NUCLEAR REGULATORY COMMISSION

Title: Advisory Committee on Reactor Safeguards
US-APWR Subcommittee

Date: Wednesday, November 20, 2013

Severe Wind v.s. Extreme Wind

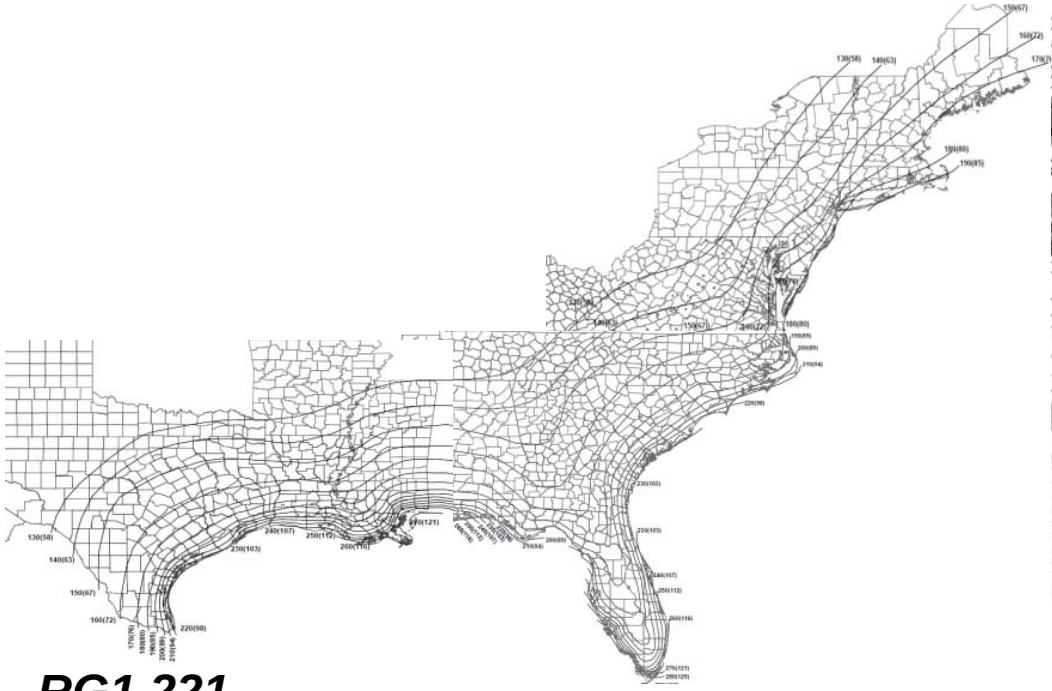
MR. OGASAWARA: Before going to the question, can I answer to the question in Section 3.3 the wind speed 155 and also 160 questions?

MR. OGASAWARA: Could you show the presentation, Page 30? One hundred fifty-five is the probability of ten to the minus two per year. This is a severe wind and 160 miles per hour is a ten to the minus six, that is extreme wind and in our DCD we call it as hurricane.

If in the site conditions the winds are higher than 155 or the number is higher than 160, the COL applicant have to show, has the responsibility for the design.

Control and Protection System Diagram

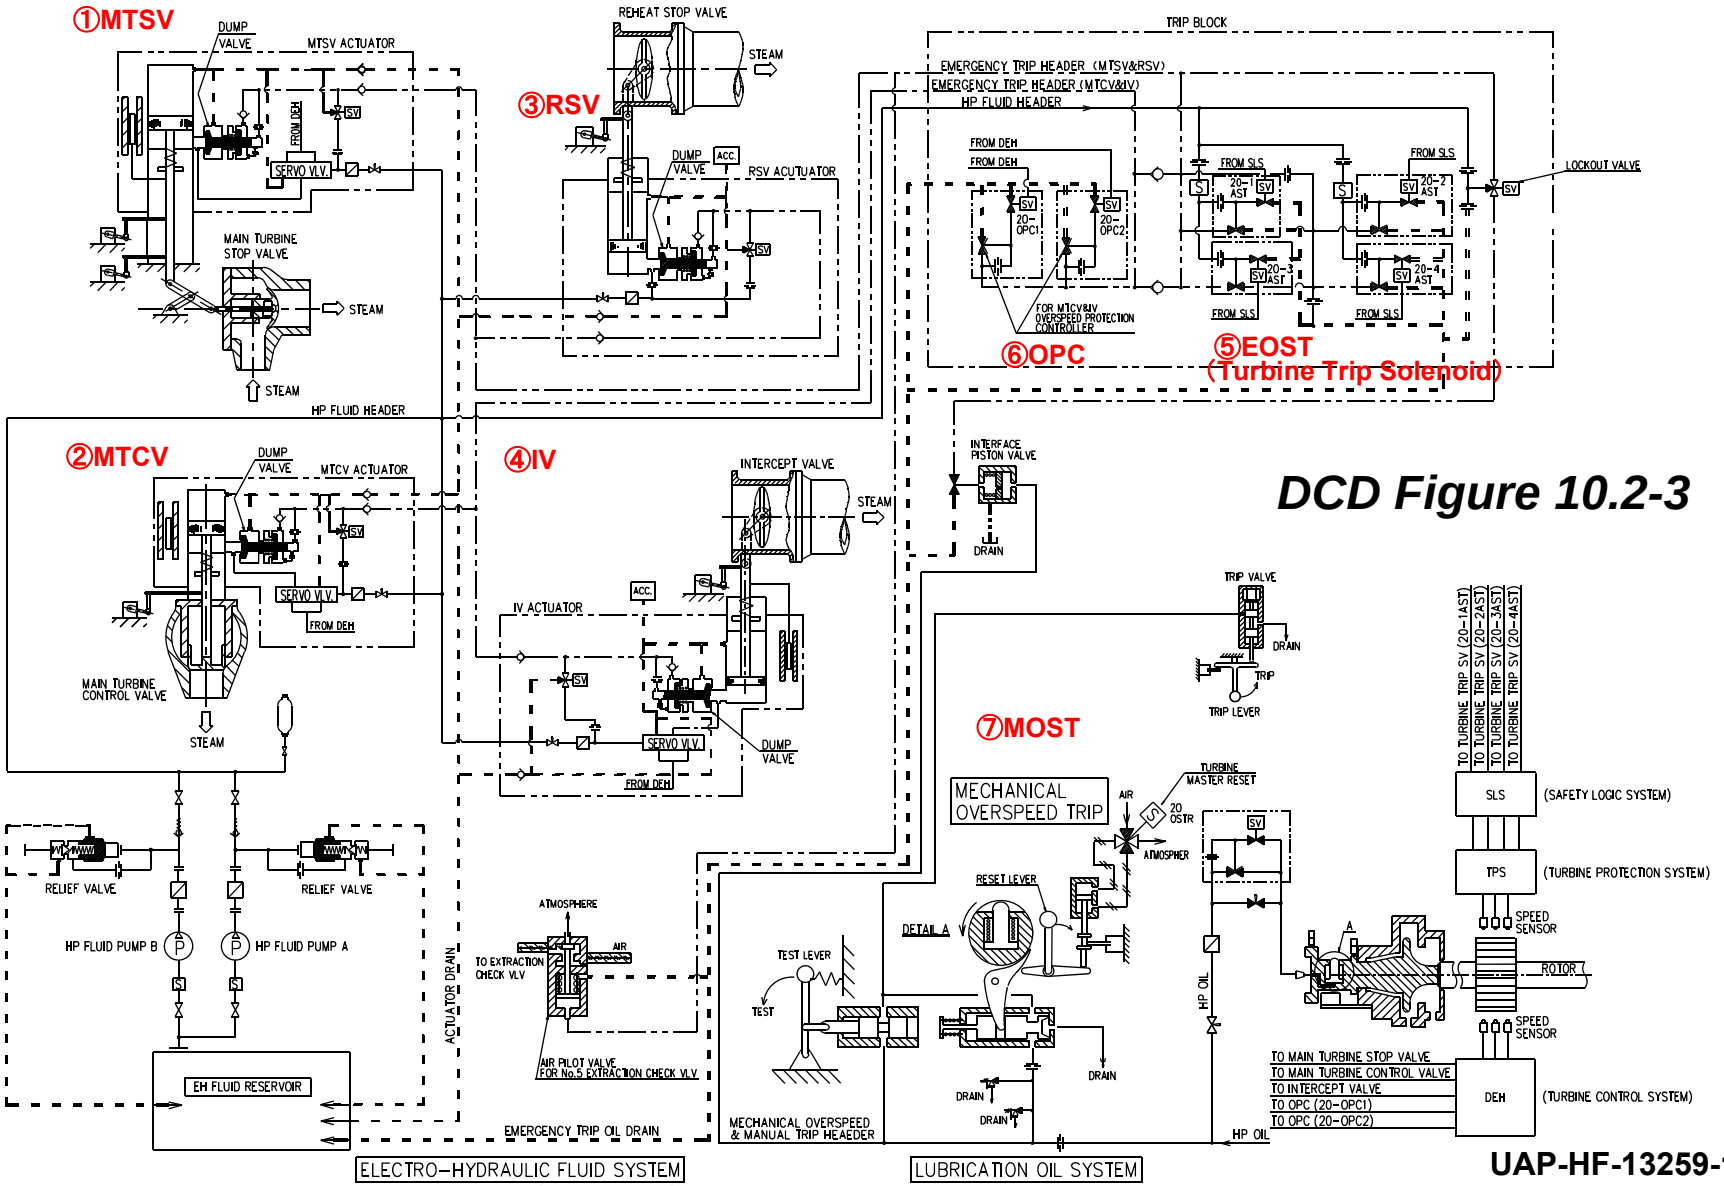
That's just simply missing. It would add to the frequency that's calculated from simply failures of the end use devices which are the stop valves and control valves themselves.

They may be standardized in Japanese plants, but they also have common cause failures and in a sense that failures of, I think, I'd have to look up equations, I think it would require failures of two solenoid valves, but if those two solenoid valves fault, none of the turbine stop valves and control valves would close.

MR. MINAMI: But when I investigate our experience in Japanese PWR plants and we investigated every failure of the turbine control system, which include the valve and the actuator, valve or sensing around control systems.

So my intention is that I didn't explicitly show the incident of the, for example, for the pickup or for the micro-CPU or for the cable or something like that, not divided into the detail, but I included all the component included in the turbine control and protection system.
